17-108WID-SP – NOAH’S EVENT VENUE

A Site Plan (SP) with Administrative Departures (AD) for the construction of a two-story, approximately 8,000-square-foot conference center and associated site improvements.

17-108WID-SP
West Innovation District - Site Plan Review
Noah's Event Center
PID:272-000356-00

Southeast Perspective (Shier Rings Road)

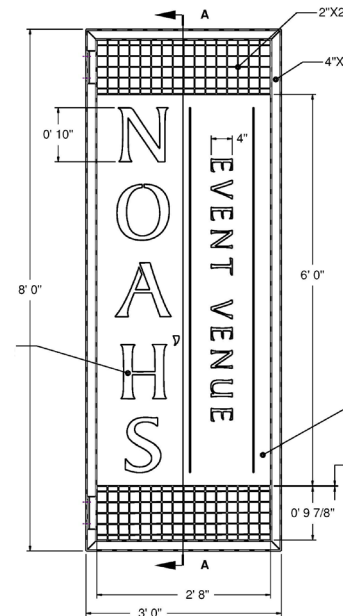
The applicant is proposing a single sign, at a size of 24 square feet, height of 20 feet, and installed perpendicular to the building projecting three feet from the face of the building. The sign consists of a black steel frame with black metal mesh inlay and stainless steel lettering comprised of "Noah's Event Venue" in two font sizes. The sign will be externally illuminated by a horizontal light fixture. The sign does not contain any additional logos or images.

The proposal exceeds both the maximum area and the maximum height permitted for projecting signs. Administrative Departures will be required to permit the location and size of the proposed sign. The projecting sign requirement within the Innovation Districts is the smallest size permitted by code, with the Historic District permitting eight square feet. Planning supports this request due to the fact that the proposal is for only one sign and the location, design, size and height shows a level of creativity not typical for these types of signs.

Request. 24 square feet.

Criteria (D) Met. The applicant is requesting to install a projecting sign at a size of 24 square feet. The sign is appropriately sized for the building and incorporates elements of the architecture to complement the architectural design. Identical color palette, materials, and character provide for a unique sign design continuing the theme of the proposal. The code provision for projecting signs in the West Innovation District is the smallest size permitted in the City, with the Historic District permitting eight square feet. Given the intended development pattern of the West Innovation District, larger setbacks and building footprints warrant the need for appropriate sign design. Based on the proposed design and integration with the proposed building, the request is not substantial in nature and meets the intent of the requirements of the Zoning Code.

Request. 20 feet.

Criteria (D) Met. The applicant is requesting to install a projecting sign at a height of 20 feet, measured from grade. The sign is a vertical projecting sign that incorporates elements of the building architecture including color palette and materials. Zoning Code Section 153.040(L)(4) permits wall signs to exceed the maximum height based upon the specific building architecture. The applicant has appropriately located the sign to complement the architectural character without sacrificing design elements.

3. Site Plan

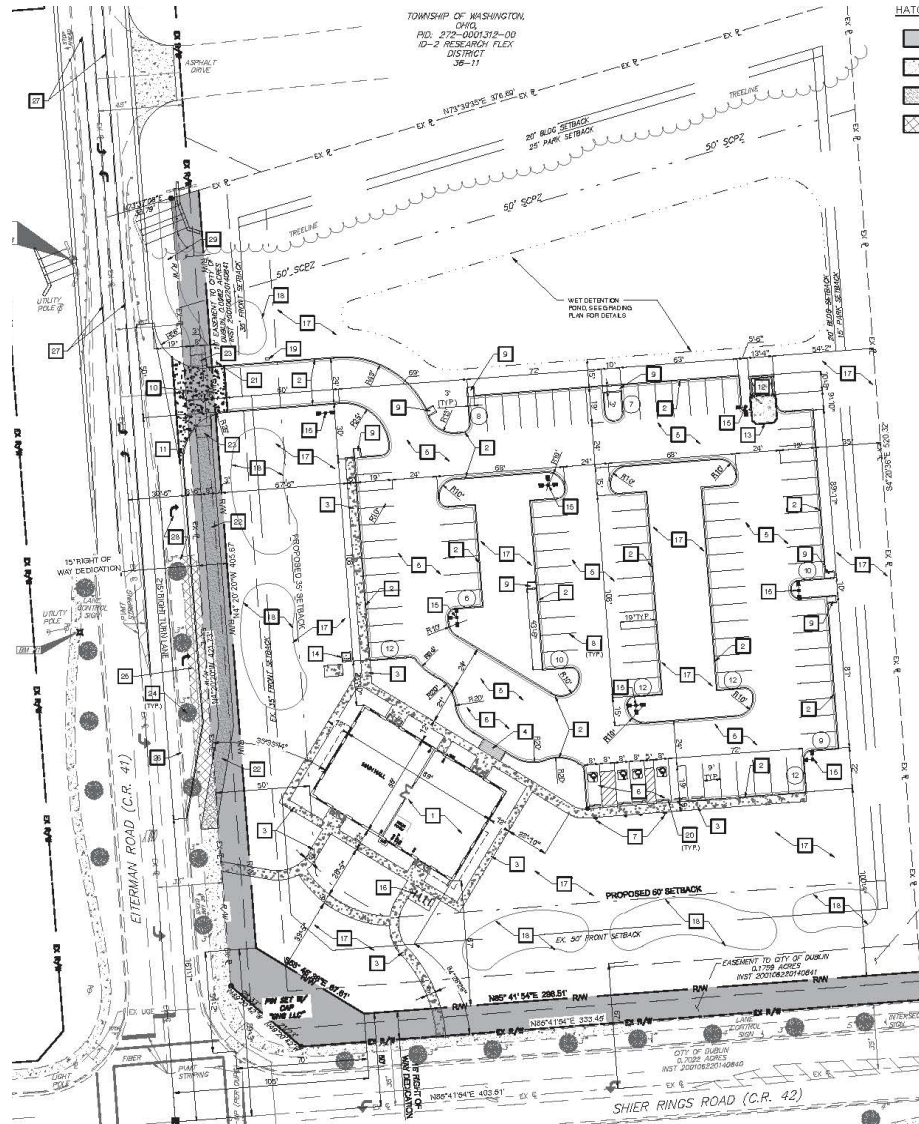
Request. 5 feet, 6 inches for the landscape island adjacent to the dumpster enclosure.

Criteria (A) Met. The applicant is requesting a smaller landscape island width to ensure efficient and safe access to the dumpster enclosure. The location of the dumpster enclosure is appropriate as it's in the rear of the property and separated from the adjacent developments. Requiring the minimum width would result in relocating the enclosure to a potentially more visible location due to the property having frontages on two public roads. The request is not substantial in nature and still meets the intent of the requirements of the zoning code.

Criteria Met with Conditions. The proposal includes adequate and efficient pedestrian circulation throughout the site providing connections to the building entrances, parking lot, and public right-of-way. Vehicular traffic is directed through a single access point from Eiterman Road with roadway improvements to provide for safe mitigation of traffic. Conflict between pedestrians and vehicles is minimized based on the proposed design allowing for safe circulation throughout the site.

Criteria Met with Conditions. The applicant has provided sufficient material to analyze the development relative to code requirements for the City of Dublin and other agencies. Additional detail and review will be conducted as part of the building permit review and any subsequent reviews required by outside agencies. The applicant will be required to ensure the Fire Department Connection (FDC) has the minimum three feet of clear space for accessibility and does not conflict with other utility connections or landscaping elements.

- 1) That the Eiterman Road widening improvements be constructed concurrently with the site and building improvements and be completed and conditionally accepted by the City prior to occupancy of the building;

- 2) That the required right-of-way be dedicated prior to occupancy of the building;
- 3) That the applicant updates the traffic study or provides a memo indicating whether or not the proposed site mitigations would be sufficient if the roadway network changes on Shier Rings Road;

- 4) That the applicant continues to work with Engineering on the appropriate Eiterman Road turn lane configuration and roadway improvements to the satisfaction of the City Engineer;

- 5) That the applicant continues to work with Engineering to demonstrate stormwater management compliance in accordance with Chapter 53 of the Dublin Code of Ordinances;

- 6) That the applicant ensures the Fire Department Connection (FDC) maintains three feet of clear space, per the Ohio Fire Code, to be verified with the building permit review; and,

- 7) That the applicant updates the landscape plan to ensure the Fire Department Connection (FDC) is not obstructed by any proposed plantings, to be verified with the building permit review.
